## REMARKS

**INSERTION DEVICE AND TECHNIQUES FOR  
ORTHOPAEDIC IMPLANTS**  
Serial No. 10/680,358; Filed October 7, 2003  
Inventor(s): Frank J. Schwab  
Contact: Douglas A. Collier (317) 238-6333  
**ANNOTATED SHEET (1 of 3)**

**Fig. 1**

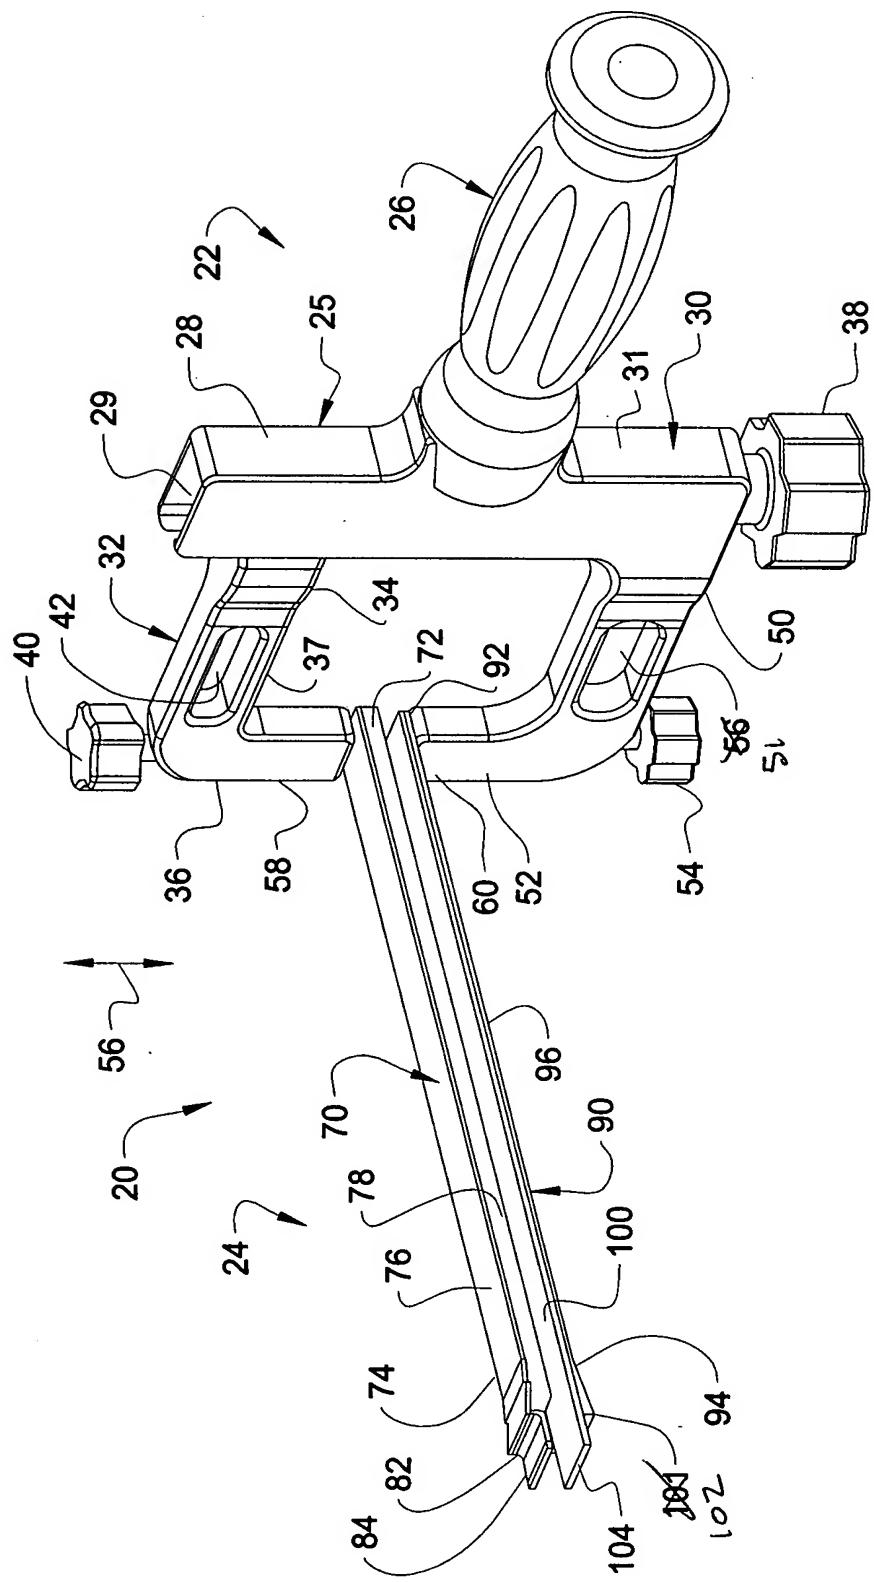
The Examiner objected to the drawings because reference character “56” was used to designate both a first hand-hole and arrows, reference character “37” was used to designate both a second lateral extension and a passage, and because reference characters “60” and “101” were not used in the specification. The Applicants have submitted herewith replacement Figures 1, 2 and 4 and have amended the specification to address the objections to the drawings.

The element “A first hand-hole 56” has been amended in both drawing sheets 1, 2 and 4 and the specification to reference character “51.” No new matter has been added by this amendment.

With regards to reference character “101”, drawing sheet 1 has been amended to change reference character “101” to reference character “102.” No new matter has been added by this amendment.
